June 1996

NAVY AVIATION

F/A-18E/F will Provide Marginal Operational Improvement at High Cost

Figure 2.1: F/A-18C/D and F/A-18E/F Range Comparison: Low-Altitude Mission Profile
Low-Altitude Mission Profile

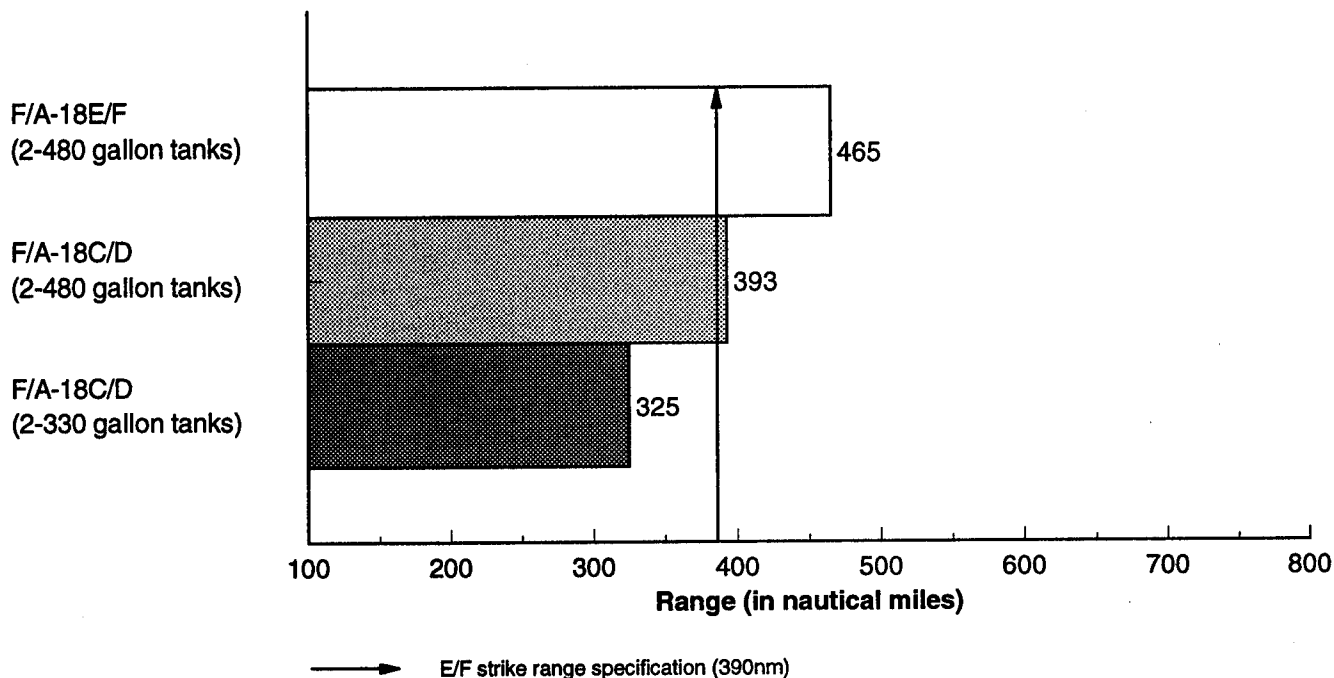
A 1991 McDonnell Douglas report, "480 Gallon External Fuel Tank," concluded that the 480-gallon external fuel tank can be carried on the F/A-18C/D inboard wing stations for carrier operations. According to the report, use of the 480-gallon tank on the C/D does not require any structural changes to the aircraft and the 480-gallon tank can be used with all weapons qualified for the F/A-18C/D. The report also stated that the new 480-gallon tank increases the multimission capability and flexibility of the F/A-18 fighter. As shown in figure 2.1, the 480-gallon fuel tank extends the C/D strike interdiction range flying low-altitude missions with two external tanks from 325nm to 393nm.¹ This increased range exceeds the 390nm specification range for the F/A-18E/F flying the low-altitude strike mission profile.

¹According to the report, adding a 330-gallon external fuel tank to the C/D's centerline station, with the two 480-gallon tank configuration, would further increase its range to 437nm.

The 480 gallon tank will not physically fit on the C/D centerline station and clear the carrier deck launch hardware during catapult. A significant modification to C/D wing structure and a pylon redesign would have to be accomplished for 480 gallon tank usage on the wing pylons.

Figure 2.2: F/A-18C/D and F/A-18E/F Range Comparison: High-Altitude Mission Profile

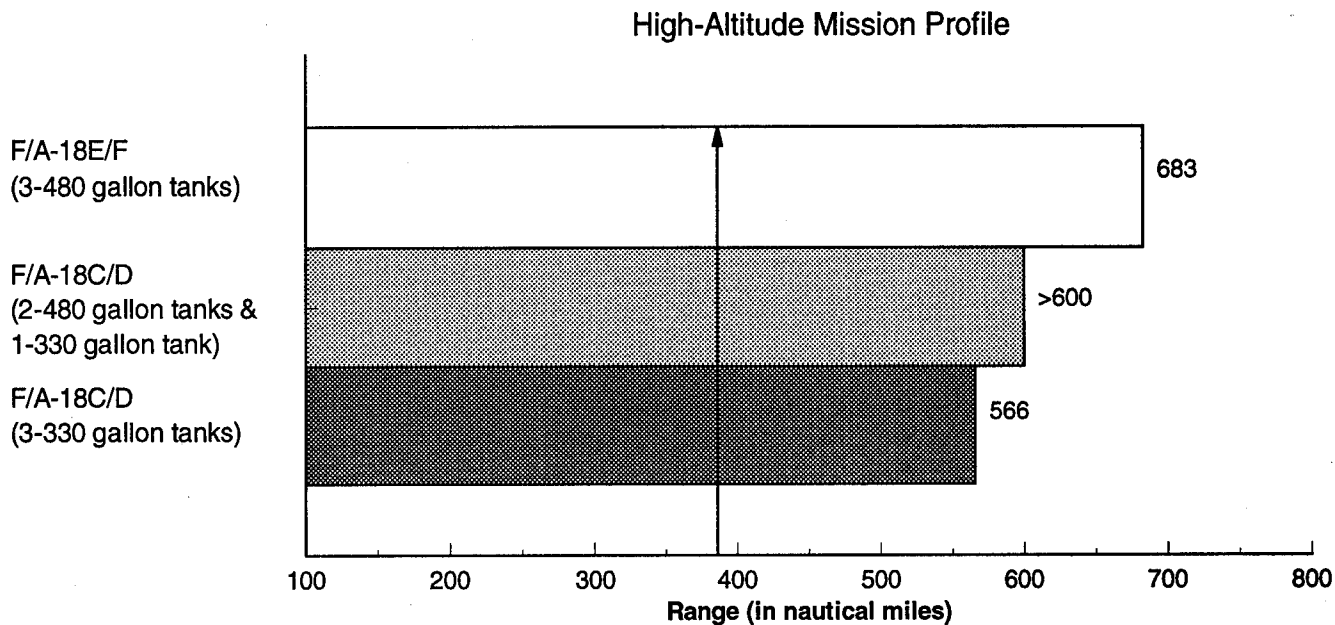
Recent Navy range predictions show that the F/A-18E/F is expected to have a 683nm strike range, carrying two 2,000-pound precision-guided bombs. The Navy plans to achieve this significant range, a range that approaches that planned for the canceled A/F-X program and the Navy's JAST variant, by flying F/A-18E/F strike missions with the larger 480-gallon tank and using a more fuel-efficient, survivable, and lethal high-altitude mission profile rather than the specified low-altitude profile.

However, as shown in figure 2.2, the same Navy predictions show that F/A-18C/D's strike ranges also increase significantly when flying at high altitudes because of increased fuel efficiency at higher altitudes. According to Navy data, the F/A-18C/D flying at high altitudes with its normal configuration of three 330-gallon external fuel tanks has a range of 566nm—176nm more than the F/A-18E/F's strike range specification.

Figure 3.2: F/A-18E/F Weapon Stations

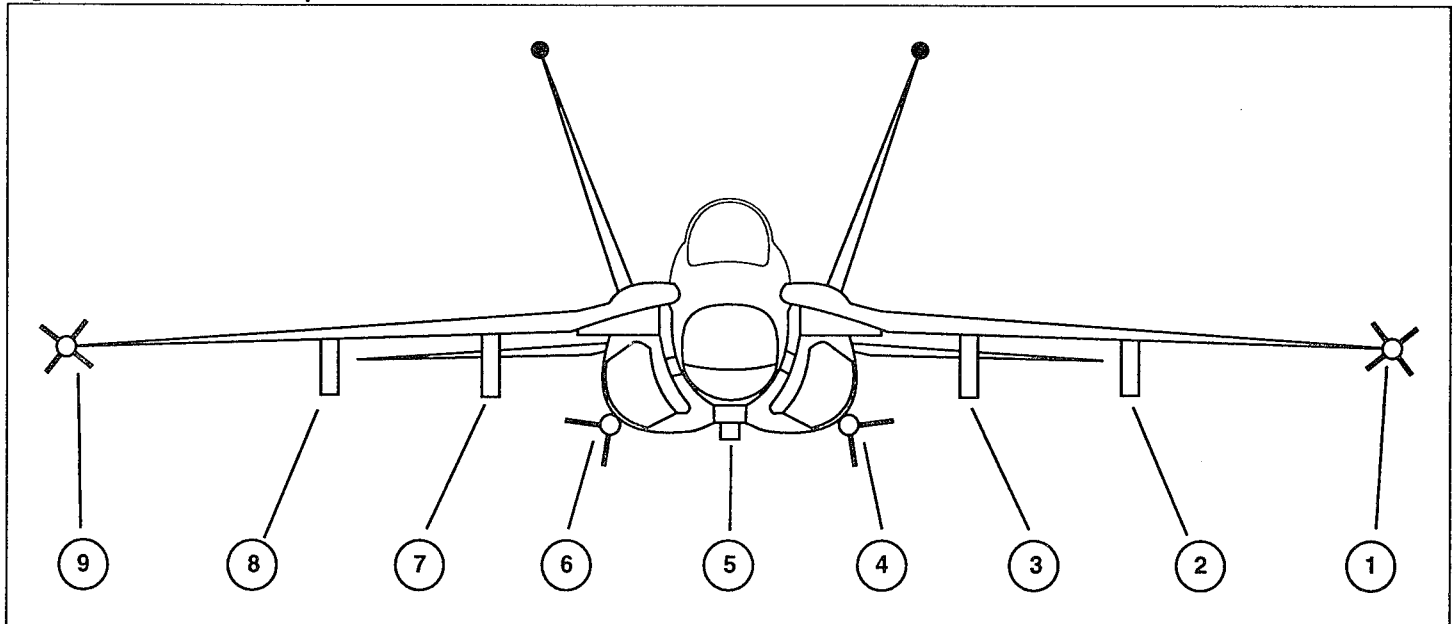
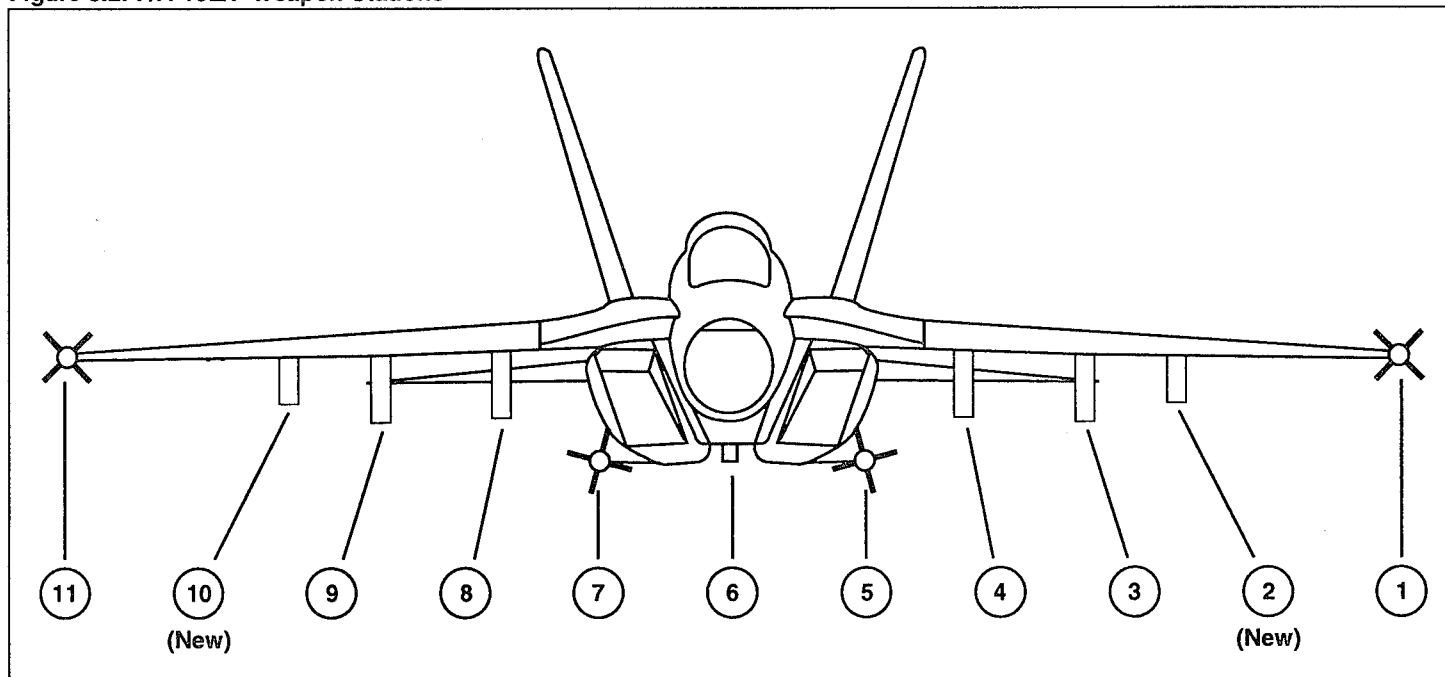
As illustrated in figures 3.1 and 3.2, airframe modifications, such as larger geometrically shaped engine inlets and additional weapon stations, have reduced the critical distance between several F/A-18E/F weapon stations.

The space reduction adversely affects the E/F's capabilities. For example, wind tunnel tests show that an external 480-gallon fuel tank or a MK-84 2,000-pound bomb, carried on the inboard station, will hit the side of the aircraft's fuselage or make contact with other weapons when released. Additionally, according to the representative, the limited distance between the new outboard and mid-board stations, coupled with outboard pylons that are shorter and closer to the wing, will cause problems when releasing large, finned weapons, such as the High-Speed Anti-Radiation Missile (HARM).

The Navy and McDonnell Douglas are studying a number of airframe fixes to correct the airflow problem. They are also studying options that place tactical restrictions on weapon deployments. These options include reducing the number of weapons the E/F carries and reducing the speed the aircraft is flying when the weapons are released.

Figure III.I: Air Speed Envelope Comparison Between C/D and E/F.

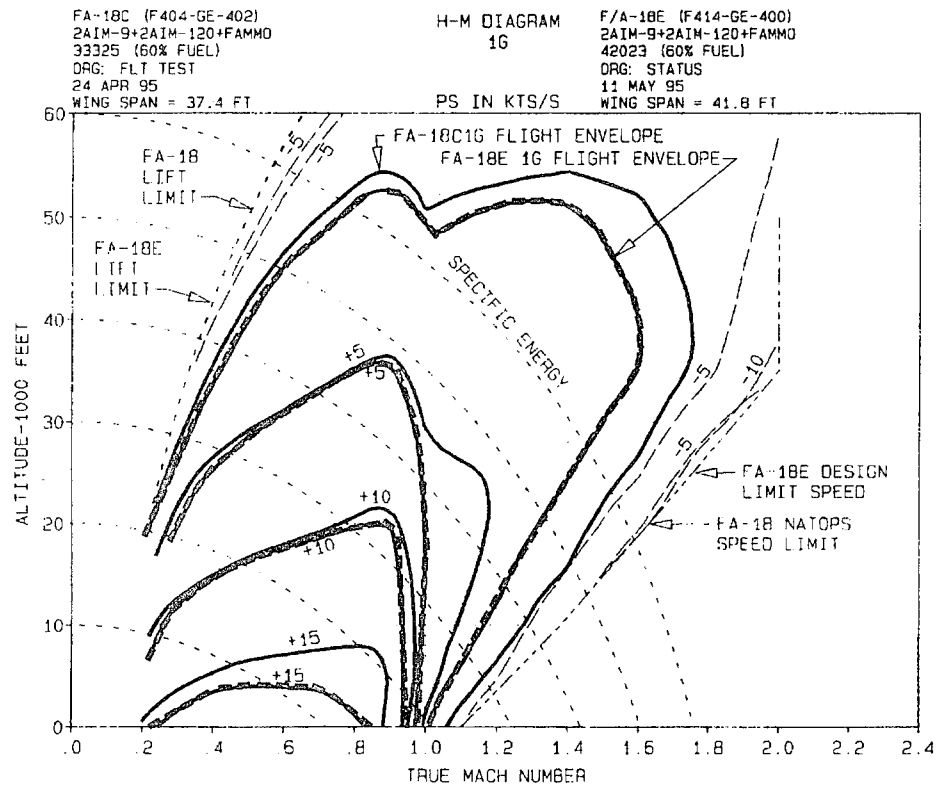
The higher specific excess power for the C/D allows the aircraft to perform better than the E/F. The following diagram, which was provided by NAVAIR, shows that the C/D with the EPE will have a better air speed flight envelope than the E/F.

DOD Figure 1: F/A-18E/F Maximum Possible Carriage of Specified Weapons

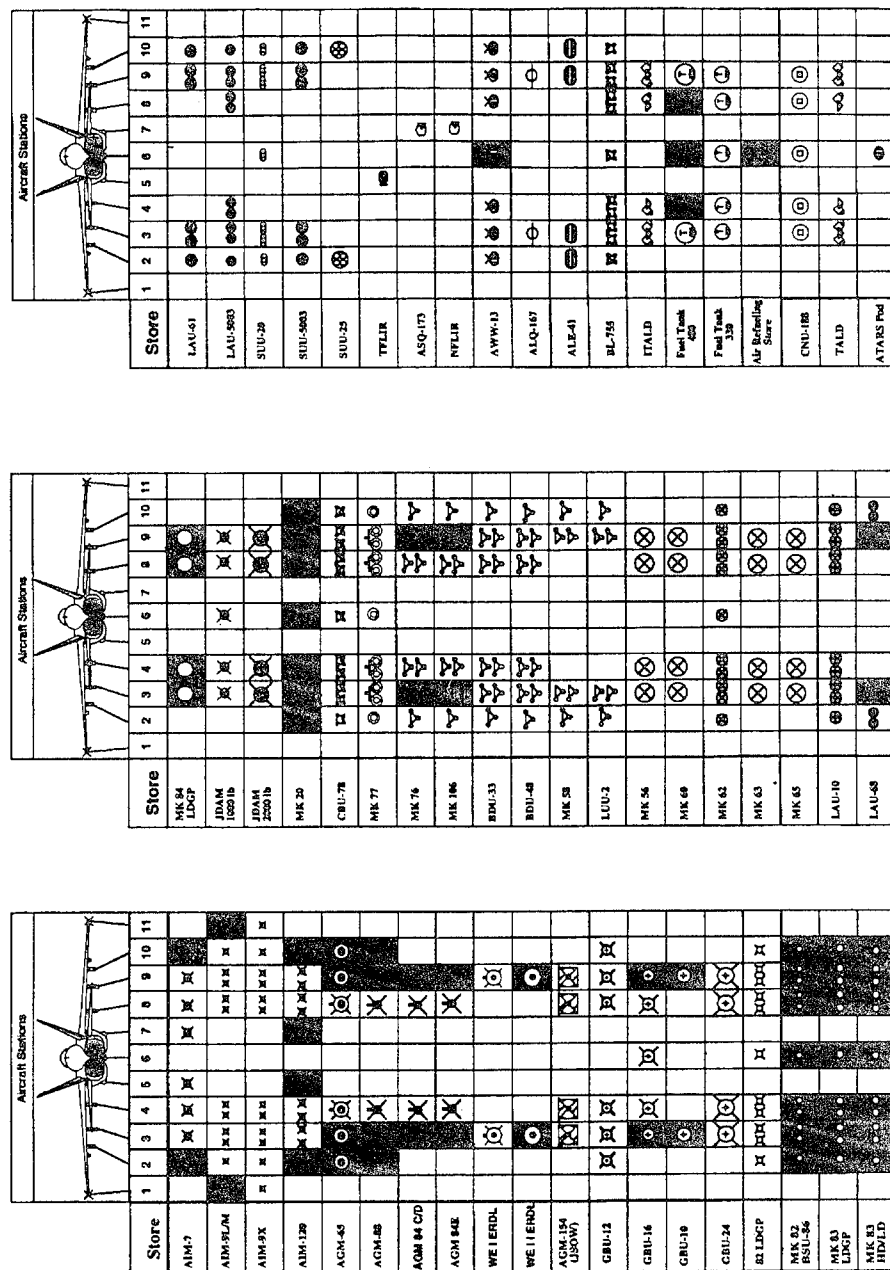
GAO fails to credit the F/A-18E/F's ability to carry the heavier precision weapons while carrying self protection weapons such as HARM, AMRAAM, and Sidewinder on the outboard pylon. The C/D would have to give up use of a heavy store pylon to carry the same protection. The outboard pylons were specifically designed for weapons mix flexibility and self protection, not for the heavier munitions (See Figure 1). The comparison below shows how the E/F carries more heavier precision weapons when going into a high threat area requiring HARM missiles.
